APPLICATION NO.	FILING DATE	FIRST NAMED INVENTOR	ATTORNEY DOCKET NO.	CONFIRMATION NO.
10/632,350	07/31/2003	Hiroshi Moriya	16869N-085900US	3966

Office Action Summary

Application No. 10/632,350	Applicant(s) MORIYA ET AL.	
Examiner Hung T Vy	Art Unit 2821

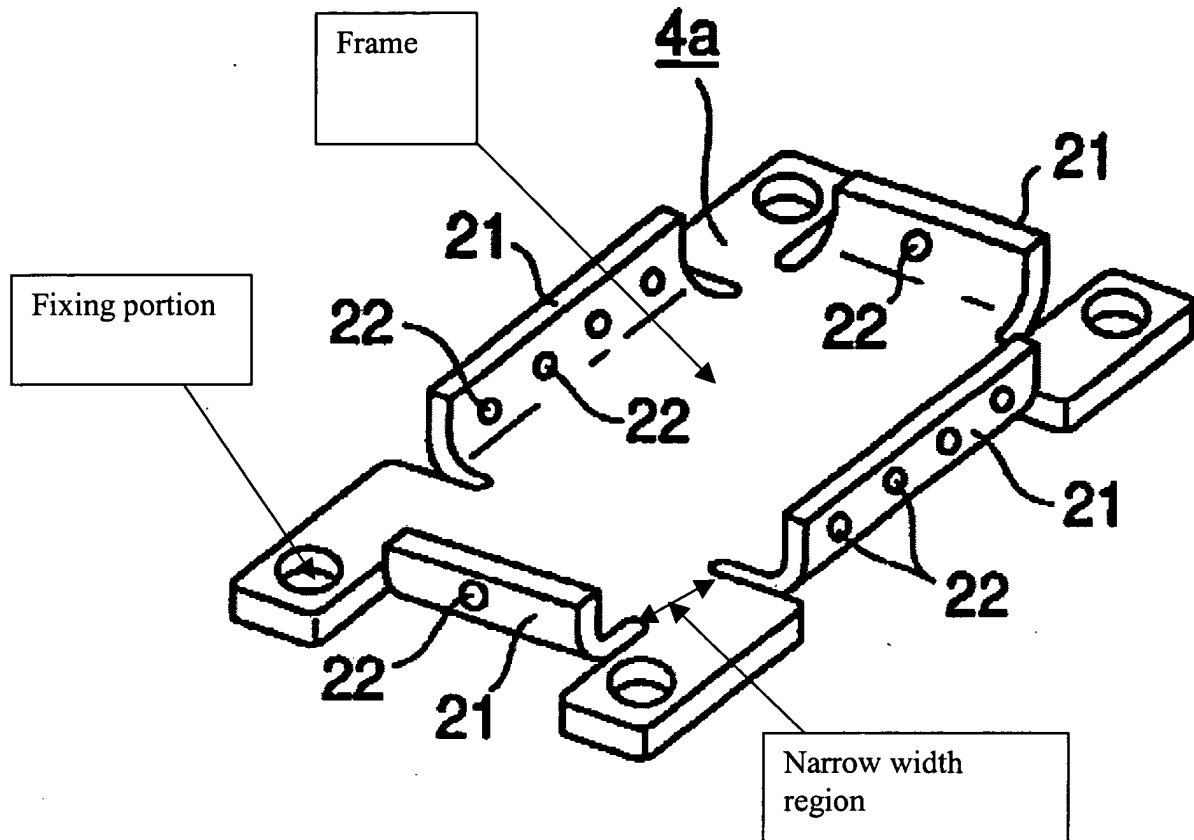
Claim 1 is rejected under 35 U. S. C. § 102 (e) as being anticipated by Kimura et al., U.S. patent No. 6,697,399.

Claim 1, Kimura et al. disclose a semiconductor laser module, comprising: a semiconductor laser element (2); a frame for storing said semiconductor laser element therein; an optical fiber (3) fixing portion being connected to said frame; a flange being connected to said frame, and having a fixing portion for fixing said frame on a substrate, wherein said flange has a narrow width region between a fixing region, including a fixing portion with said substrate therein, and said frame, and said narrow width region is narrower than width of said fixing region (See figure below).
